**Response to
Earth Systems Review –
Water Balance Modelling and
Surface Water Management**

State Significant Development No. 5765

October 2022

Bowdens Silver Project

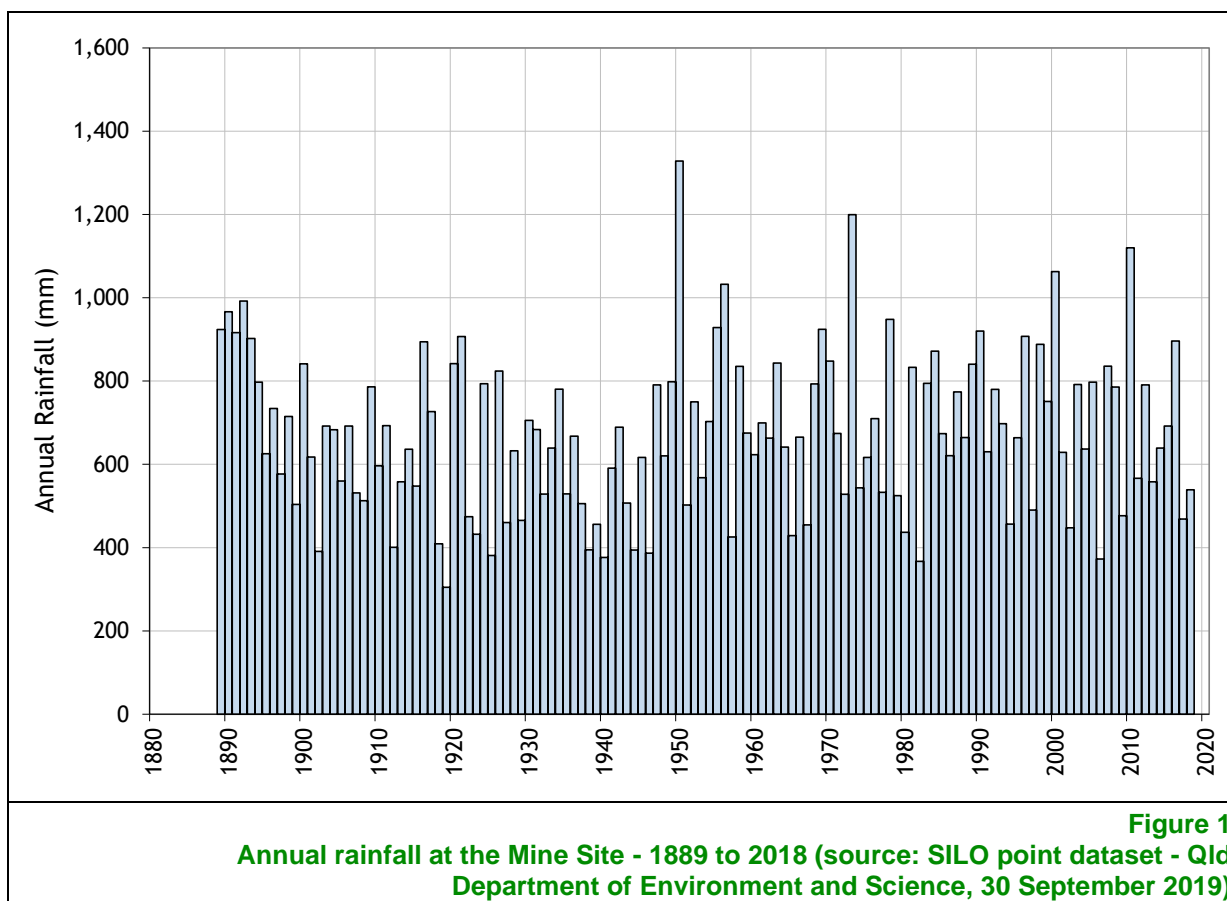
monthly observational data to daily). It was therefore important that this data was sourced and used. However, a clerical oversight has meant that Figures 3.1, 3.2 and 3.3 of WRM (2022) were not updated with the September 2019 dataset.

For completeness, updated Figures 3.1, 3.2 and 3.3 of WRM (2022), are provided as **Figures 1, 2 and 3** and prepared using the September 2019 SILO dataset are presented below. Review of **Figures 1 and 2** identify a decrease in both annual total rainfall depths and average monthly rainfall whilst evaporation remains largely unchanged. The linear regression analysis presented on **Figure 3** displays the correlation (R^2 value) between measured (Mine Site) and SILO monthly rainfall data. Such an analysis is used to assess the strength of data correlation whereby 0 = weak and 1 = strong. **Figure 3** shows the September 2019 dataset as having an even stronger correlation ($R^2 = 0.95$) than that derived from the January 2019 dataset ($R^2 = 0.93$).
